# Access Compliance Report

## Public Rights-of-Way

### (Curb Ramps)

Intersection ID: 28157	Main Street: LANDEN_DR	Cross Street: LONGMONT_DR	Location: NW
ADA ID: BBB506309FA3	Ramp Type: BlendTrans1	Initial Pass/Fail: Fail	Overall Compliance: No
			Severity Score: 21.25

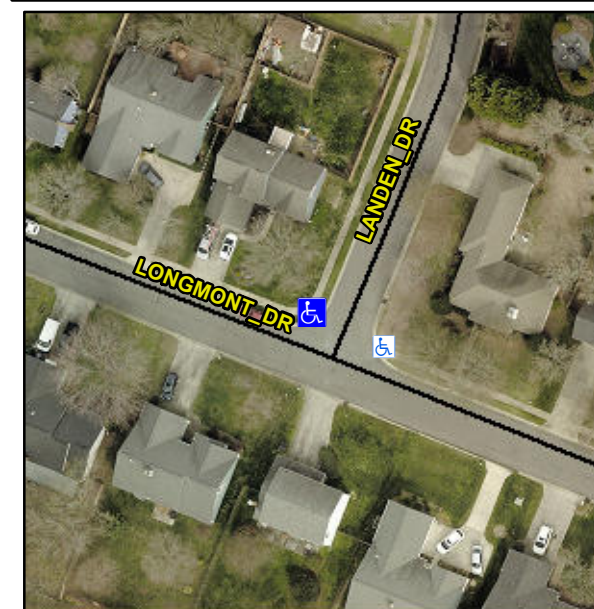
**Not Found, R304.5.1, R304.5.3**

Compliance	Description	Data	Compliance	Description	Data
N/A	Ramp Length (in)	46.5	Yes	BlendTrans Slope (%)	4.5
No	Ramp Width (in)	39.0	No	BlendTrans XSlope (%)	5.9
N/A	Flare Type LT	N/A	N/A	Flare Type RT	N/A
N/A	Flare Slope LT (%)	N/A	N/A	Flare Slope RT (%)	N/A
N/A	Flare Traversable LT?	N/A	N/A	Flare Traversable RT?	N/A
N/A	Landing Length (in)	N/A	N/A	DWS Provided?	N/A
N/A	Landing Width (in)	N/A	N/A	DWS Contrast?	N/A
N/A	Landing Slope (%)	N/A	N/A	DWS Length (in)	N/A
N/A	Landing X Slope (%)	N/A	N/A	DWS Full Width?	N/A
N/A	Landing Curb? (Y/N)	N/A	N/A	DWS Offset (in)	N/A
N/A	Shared Landing?	N/A			
N/A	Gutter Ponding?	N/A	N/A	Gutter Slope (%)	N/A
N/A	Gutter Lip Ht (in)	N/A	N/A	Gutter X Slope (%)	N/A
N/A	Painted X Walk1?	No	N/A	Painted X Walk2?	No
	X Walk 1 Direction	To S		X Walk 2 Direction	To SE
	X Walk 1 Width (in)	N/A		X Walk 2 Width (in)	N/A
	X Walk 1 Slope (%)	3.5		X Walk 2 Slope (%)	0.1
	X Walk 1 X Slope (%)	0.8		X Walk 2 X Slope (%)	2.9

N/A	Ramp inside XWalk1?	N/A	N/A	Ramp inside XWalk2?	N/A
	Road Slope (%)	2.6		Clear Space?	N/A
	Road X Slope (%)	3.5	N/A	Clear Space to XWalk (in)	N/A
N/A	Any Obstructions?	N/A	N/A	Storm Grate/Utility Hazard?	N/A
	Obstruction Type			Storm Grate/Utility Type	
		N/A			N/A
			Yes	Surface Condition? (G/P)	Good
			No	Curb Slope (%)	7.5

**Remove & Replace Curb Ramp With Two New Directional Ramps or Equivalent.**
